2CAN051202

May 21, 2012

SUBJECT: Additional Information Related to Request for Alternative ANO2-ISI-007  
Code Case N-770-1 Baseline Examination  
Arkansas Nuclear One, Unit 2  
Docket No. 50-368  
License No. NPF-6

**Additional Information Related to  
Request for Alternative ANO2-ISI-007  
Code Case N-770-1 Baseline Examination**

**DM Weld # 08-014**

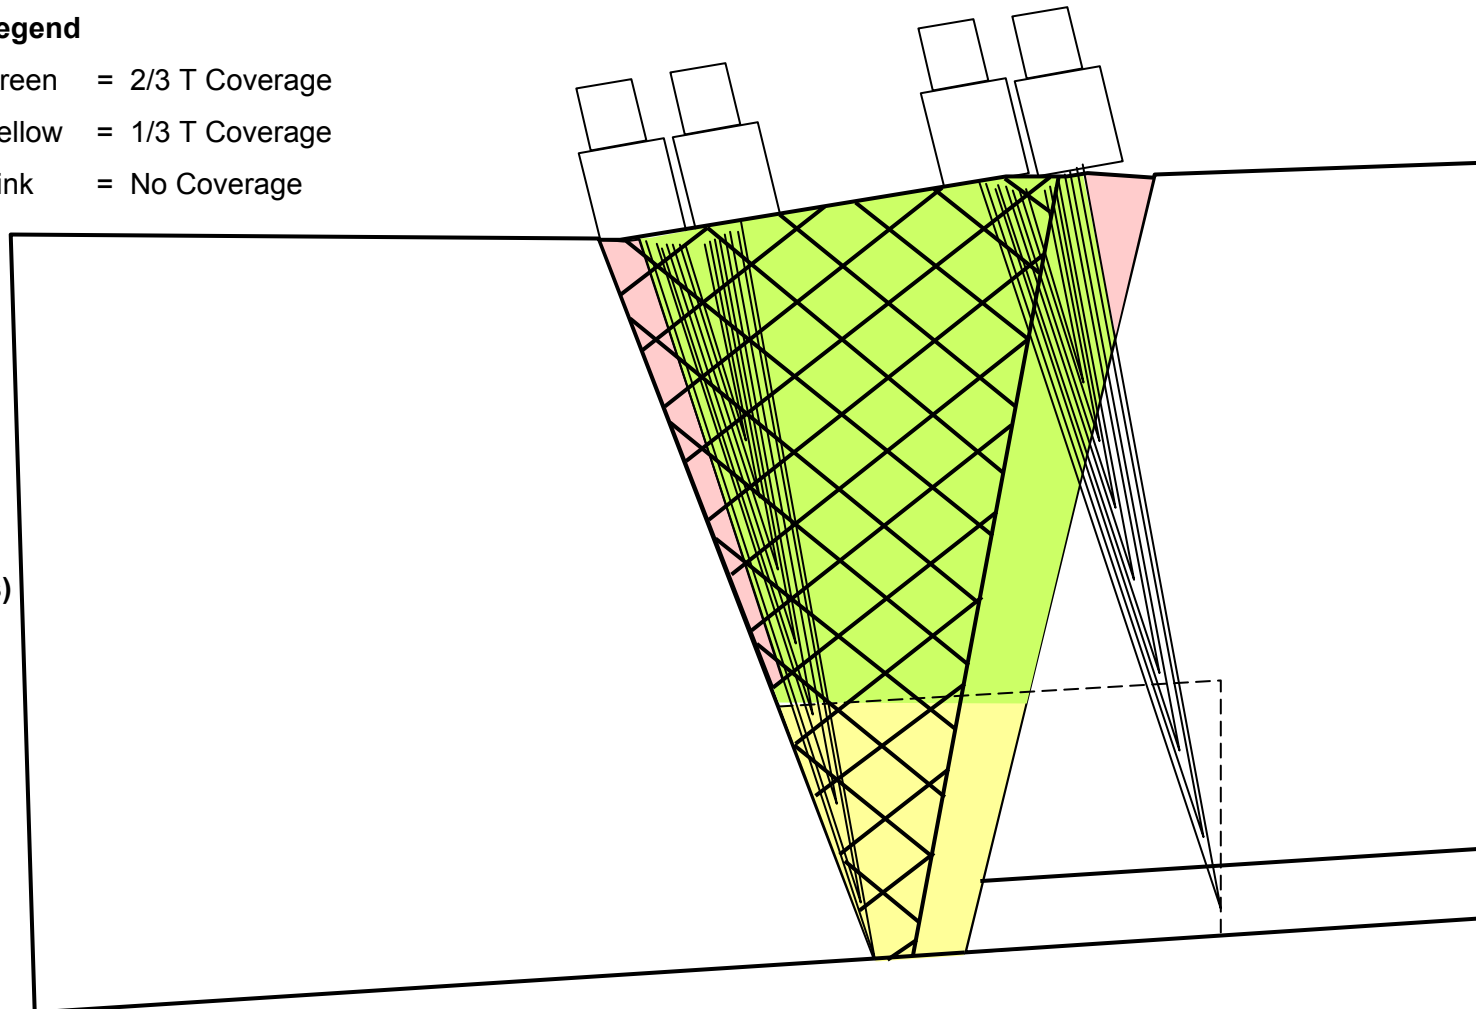
- 1. The response to Question 5 of the Request for Additional Information (RAI) response states that the coverage limitations are the result of irregular surfaces or tapered surfaces. The staff is concerned by the different coverage which would result from these geometries; intermittent lack of coverage due to irregular weld surfaces is significantly different than a continuous lack of coverage at the root which could result from a tapered weld surface. Please describe the reason for the lack of examination coverage for the susceptible material in each weld and, if due to weld taper, whether the root of the weld is being examined.**

- 2. In Table 1 of the RAI response, the coverage in the circumferential direction is identical for the ferritic material and the susceptible material. Please describe how this is occurs.**

<b>Component Number</b>	<b>Lower 1/3 Thickness (T) Circumferential Scan Coverage %</b>	<b>Upper 2/3 T Circumferential Scan Coverage %</b>	<b>Sketch Location of Circumferential Coverage Limitation of the Susceptible Material Volume</b>
08-014	100	92	Limitation in upper 2/3 T inconel weld at cast austenitic stainless steel (CASS) bevel preparation area and at cap transition to elbow.
09-008	55	64	Limitation to coverage appears to be concave area near center of weld cap indicating missed scan coverage is in the inconel weld, cap to root.
10-014	14	73	Limitation appears to be from weld taper and indicates the majority of the limitation is in the inconel weld and adjacent butter region with no coverage of weld root area.
11-008	62	73	Limitation to coverage appears to be convex area near center of weld cap indicating missed scan coverage is in the inconel weld, cap to root.
12-014	50	86	Limitation appears to be from weld taper and indicates the majority of the limitation is in the inconel weld with little coverage of weld root area.
